# UNITED STATES PATENT AND TRADEMARK OFFICE

10/563,954

<b>Office Action Summary</b>	<b>Application No.</b> 10/563,954	<b>Applicant(s)</b> PFEIFFER, WERNER	
	<b>Examiner</b> /Robert James Popovics/	<b>Art Unit</b> 1797

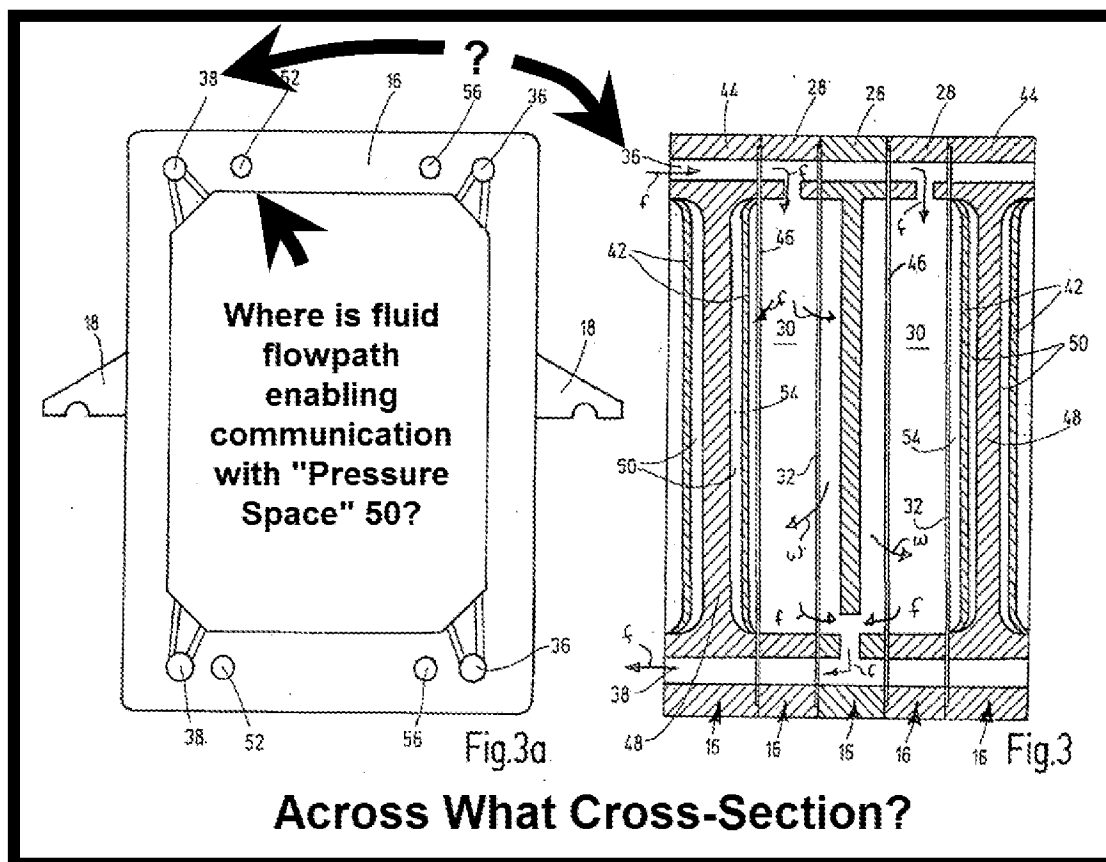
Claims **8-21** are rejected under 35 U.S.C. 112, first paragraph, as failing to comply with the enablement requirement. The claim(s) contains subject matter, which was not described in the specification in such a way as to enable one skilled in the art to which it pertains, or with which it is most nearly connected, to make and/or use the invention. Operation of the claimed process and device, when viewed in light of the originally filed disclosure, remains a mystery.

[0031] In the embodiment shown in FIG. 3, on the right one respective deep-bed filter medium as the respective laminar filter 32 is inserted toward the edge-side boundary of the filtrate space 30 viewed in the direction of looking at FIG. 3. On the opposite side, this time a filter cloth 46 of conventional structure as another filter medium borders the filtrate space 30. As FIG. 3 furthermore shows, along one middle plane the respective membrane plate 44 has two membranes 42 which are separated by one chamber wall 48. Between the chamber wall 48 and the respective membrane adjacently opposite, a pressure space 50 is formed by delivering and draining a pressurized fluid by way of the pressure channels 52 (compare FIG. 3a) the respective membrane 42, for example in the form of a rubber-elastic membrane, being pressed in the direction of the adjacently opposite filter cloth wall 46, the respective filter cloth 46 being provided with a definable fluid permeability. Furthermore, the respective membrane 42 with the filter cloth 46 assignable thereto borders a washing chamber 54 which can be supplied with a definable washing liquid by way of other channels 56 (compare FIG. 3a).

How?

Given the inconsistencies and lack of clarity as to what cross-section is being referred to, the drawings submitted on **August 31, 2009** have **NOT BEEN APPROVED**.
